Date: April 1, 2025

From: Rebekah Leto, AICP, Town Planner

Subject: Preliminary Plat review for 19-lot residential subdivision, located in the N ½ of the SW ¼ of Section 13, Town of Eagle. Tax Key No. EGLT 1779.999.001

PRELIMINARY PLAT  
OF  
LONG MEADOW

Exhibit A – Preliminary Plat dated 2/5/25

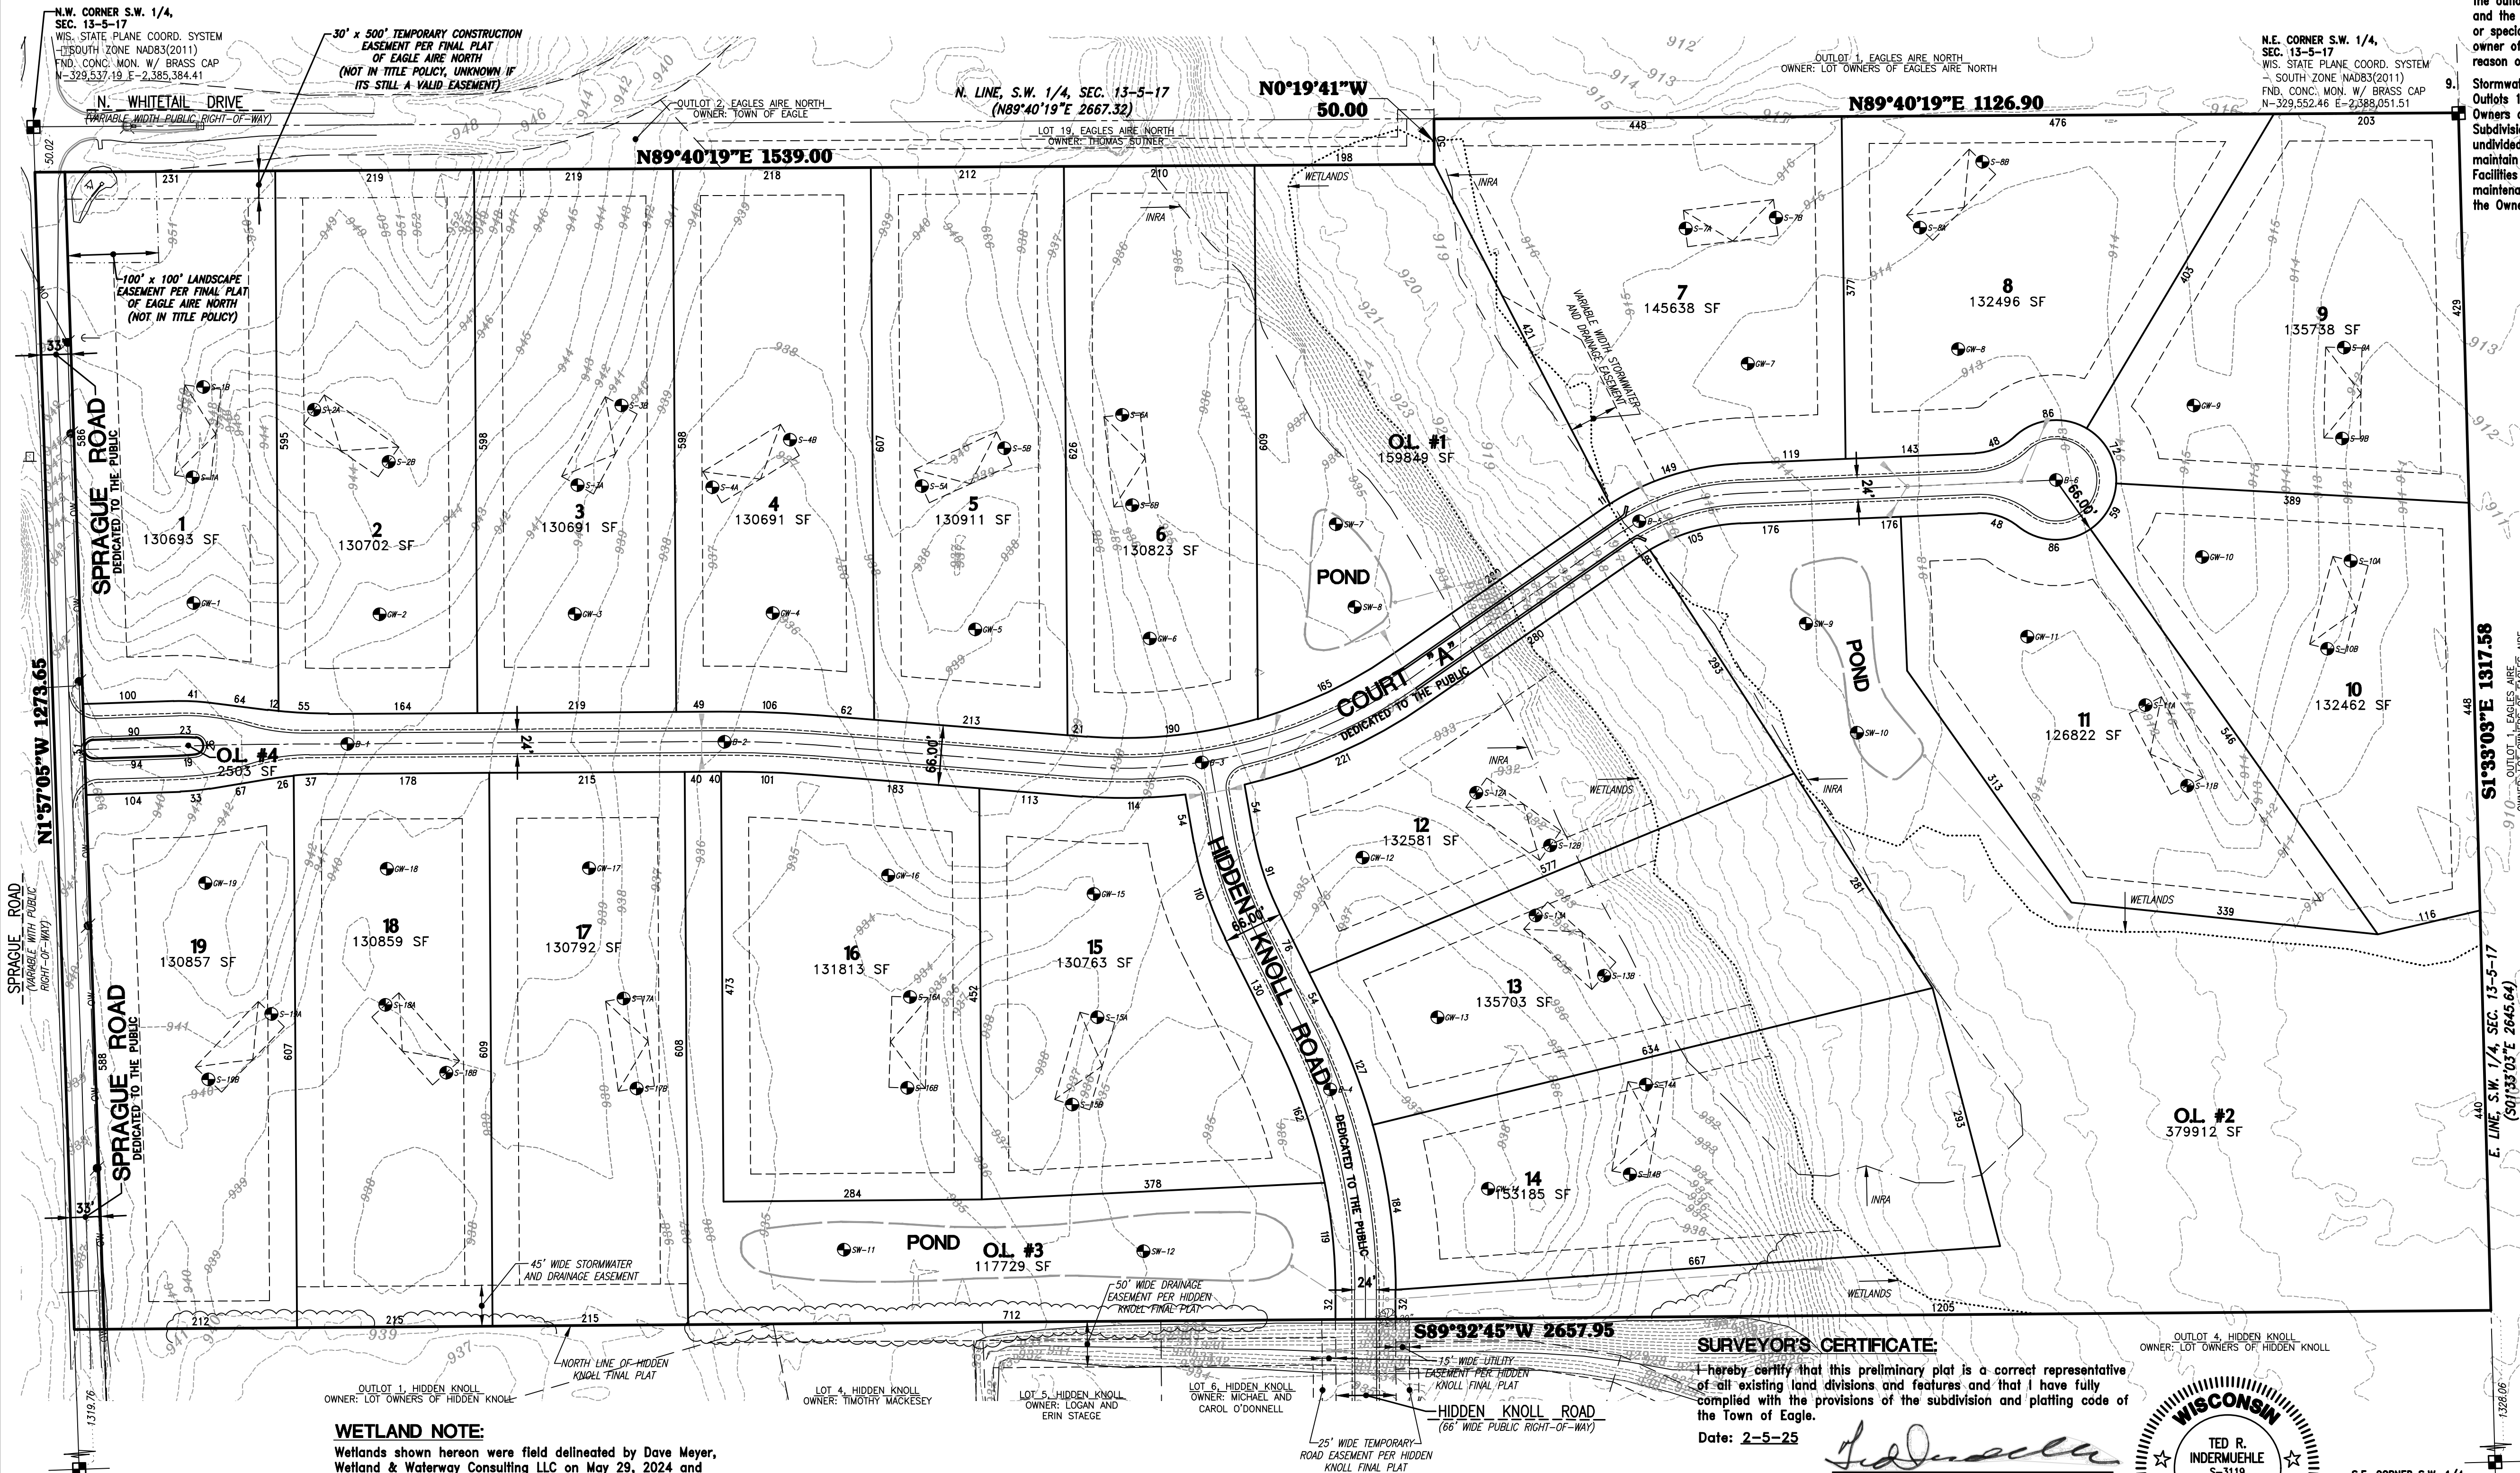
The subdivision entrance is from Sprague Road with a road extension to Hidden Knoll Drive to the south. The proposal requires crossing the wetland and INRA to an area of upland located in the east portion of the site that allows for five lots and contains a cul-de sac. The cul-de sac length and radius comply with the ordinance requirements.

A DNR permit will be required for the wetland crossing. The developer will need to avoid and minimize impacts to the wetland to meet state standards. Documentation will need to be provided to the DNR that shows how the wetlands impacts are the smallest amount possible, in addition to providing an alternatives analysis.

See enclosed memo dated March 4, 2025. Preliminary Stormwater approval has not been obtained.

On February 21, 2025, the Environmental Health Division (EHD) certified that there are suitable soils on each individual parcel to support a residential use after a review of soil boring data. Lots 1-6 and 12-19 have conventional type soils. Mound-type soils are present on lots 7-11. The mound sites shall be protected from land alteration. EHD recommends septic areas and 15 ft. of downslope to be staked off to protect the sites from disturbance. Note that the septic boxes on the preliminary plat do not accurately represent the size, layout or location of the eventual septic system.

1. All comments of the Town Engineer Memo dated 3/4/2025 shall be complied with. Preliminary Stormwater Approval shall be granted prior to land altering or the submittal of a Final Plat or revised Preliminary Plat. If Preliminary Stormwater Approval requires the substantial modification of the layout as shown on the 2/5/25 plat, a revised Preliminary Plat is required to be submitted to all entities.
2. Modify the zoning requirements to state the road setback is 35 ft. and modify the building envelopes shown on the plat to match.
3. Existing wells and septic systems within 50 ft. of the exterior plat boundary shall be shown on the plat.
4. Buildings within 50 ft. of the exterior plat boundary shall be shown on the final plat.
5. Any existing farm drain tiles shall be identified on the plat, including location, purpose and status.

6. Vision corner easements shall be placed on Lots 1, 12, 15 and 19 in accordance with Section 500.562 of the Municipal Code. Restrictive language of the easement area shall also be placed on the plat.

7. The Town Board must approve a waiver from the 2.5:1 maximum Depth to Width Ratio requirement for Lots 1-6, 13-14 and 17-19 as they do not meet this requirement by approximately 17-33 feet. If approved, a note shall be added that states, "The Town Board waived the 2.5:1 depth to width ratio requirement for Lots 1-6,13-14 and 17-19 on \_\_\_\_\_".

8. A Land Management Plan shall be prepared by the developer and submitted to the Town Board for review and approval. The plan must address long-term management and monitoring of the wetland and INRA within the Outlot(s) and on private Lots 6 and 12-14. The final approved plan shall be recorded in the Waukesha County Register of Deeds by the developer immediately after plat recordation. Depending on the outcome of the botanical survey completed by SEWRPC, the developer may wish to contact the Waukesha County Land Conservancy to gauge interest in maintaining the wetland and INRA areas in accordance with the approved Land Management Plan.

9. The wetland and INRA areas on Lots 6 and 12-14 shall be contained within an "Open Space Easement" to ensure the property is consistent with the purpose of preserving the area as open space in perpetuity. The easement language can be incorporated into the Land Management Plan noted above or noted directly on the plat.

11. A Master Grading Plan shall be submitted for review and approval by the Town Engineer. A copy of the final Master Grading Plan shall be provided to the Town Planner to ensure future residential development on individual lots is in compliance with the approved Master Grading Plan.

12. According to the soil survey of Milwaukee and Waukesha Counties, lots in this subdivision may contain soils with seasonal high groundwater located less than 3' below ground surface. Therefore, a soil analysis for all lots within the development shall be completed to ensure that basement floor elevations will be at least one (1) ft. above the estimated seasonal high groundwater conditions. Minimum basement floor elevations must be identified on a Master Grading Plan or Final Plat for any lots with limiting factors.
